Planning & Zoning Commission Hearing: November 16, 2023

## 209 Cherry Street Multifamily Development – #PDP230006

This Project Development Plan (PDP) proposes to develop a seven-story residential building with structured parking.

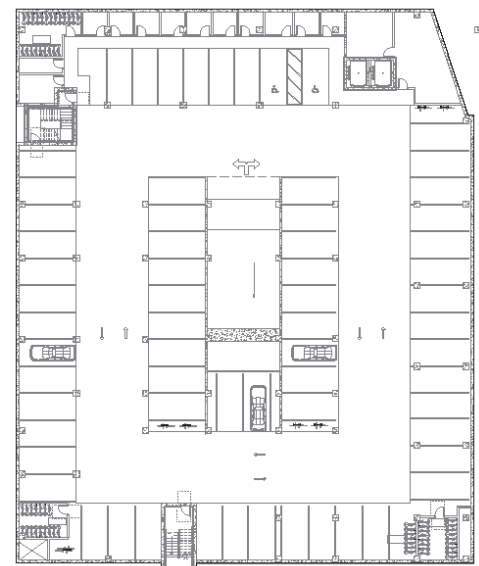
**Contextual Setbacks – Is Modification Needed?** Applicants and staff questioned whether a modification is needed for the 24-foot curb-to-building setback, because the Land Use Code has a citywide standard that allows a 'contextual setback' to fall at any point between a required setback in the zone district and an abutting building. (Section 3.8.19(B).)

The proposed setback matches the setback of the abutting building; and staff find that a matching setback complies with the contextual setback provision. (Setbacks in this case being from curb to building rather than typical setbacks from right-of-way line to building.)

Note that the curb-to-building space is the same even though the proposed building is forward of the abutting building, because the plan moves the curb inward into the street.

The abutting building is placed behind a raised private walkway terrace that is on the right-of-way line; and the proposed building aligns with that terrace wall on the right of way line.

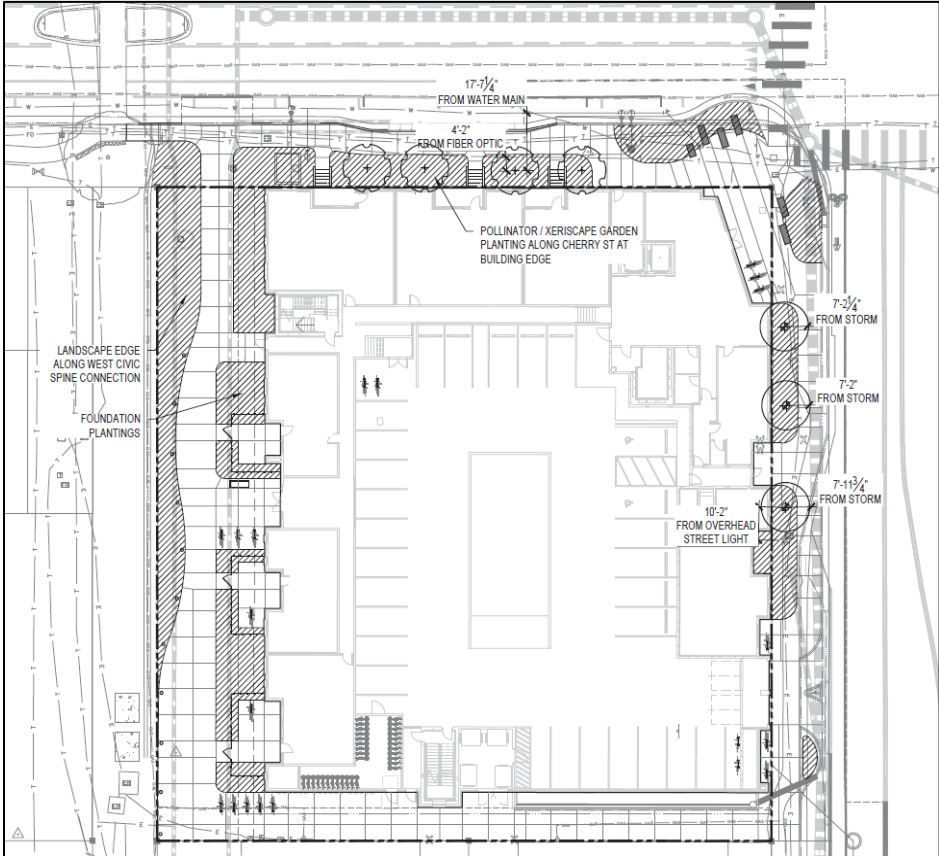
The proposed building fits with that general scale of building and staff finds no compelling significance of 6 stories versus 7 within that height limit. In general, staff finds that the human scale established by the building base is the more important scale effect.

**“Equal or Better”.** The proposed plan meets the purposes of the standard as well as a standard plan because the building is the same size as it could be with one less story, but taller stories (which is very common).
